Progressive Mercury/040 Jumper Update: 3000T

Progressive Mercury/040 GAL Update: 030 Boot Conflict

MERCURY SUPPLEMENTARY JUMPER SETTINGS

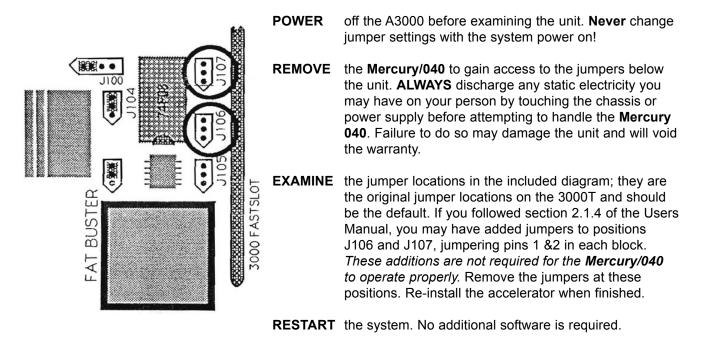
We have recently determined that the manual for the Progressive Mercury/040 is incorrect concerning the jumpering of the 3000T. Field testing has revealed that the board works perfectly without changing or adding any jumpers, despite section 2.1.4 in the Users Manual. While our jumper settings do not appear to change the performance of the system, we do recommend resetting the system's jumpers to avoid future conflicts. Please follow these procedures:

NOTE: Some users have taken to changing jumpers other than what we've suggested. This may change internal system timings that can lead to lockups, non-validated harddisks and floppies and complete systemwide failures. PP&S strongly suggests that you restore the jumpers to the default settings (as in the diagram) before serious data failure occurs.

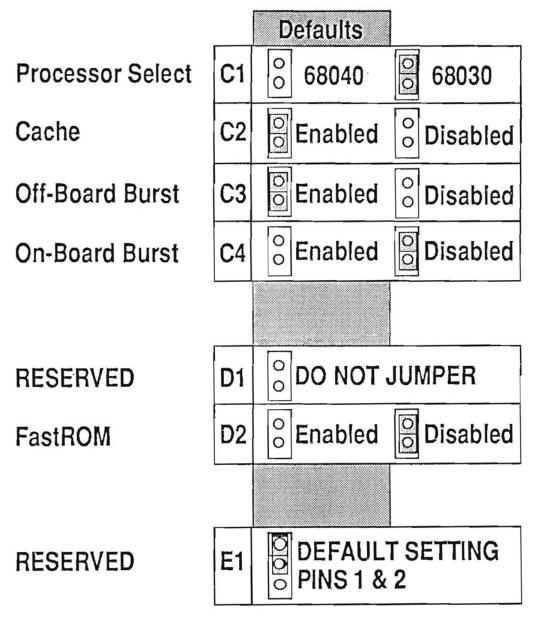
We have found that some early-release Progressive **Mercury/040** boards do not boot directly to the 68040, but rather to the native 68030 of the Amiga 3000's motherboard. This can happen on the first power-up or as a warm reboot. We have isolated this problem as being in a GAL chip on the **Mercury/040** in socket U301, and we recommend this chip change to alleviate the problem:

L	REMOVE	the chip gently using a chip removal tool, or a small flat-tip screwdriver.
CHIP U301 LATTICE GAL 22v10B-10LP		INSERT	the replacement Texas Instruments chip gently into the U301 socket, Take care that the notch in the chip orients to the left (as shown) and that the pins do not bend underneath the chip during installation.
]	INSTALL	in system as usual. The Mercury/040 will now always cold-boot into the 68040 mode, as expected. This will not affect the ability of Mercury/040 to switch between 040 and 030 modes.
		REPLACE	the original Lattice GAL chip in the protective foam block provided with the replacement GAL, and send it back to Progressive. This MUST be done to avoid being charged for the update.

After inserting the replacement GAL, the Progressive **Mercury/040** will operate normally under the Workbench 2.0 operating system. Please send the Lattice GAL to:
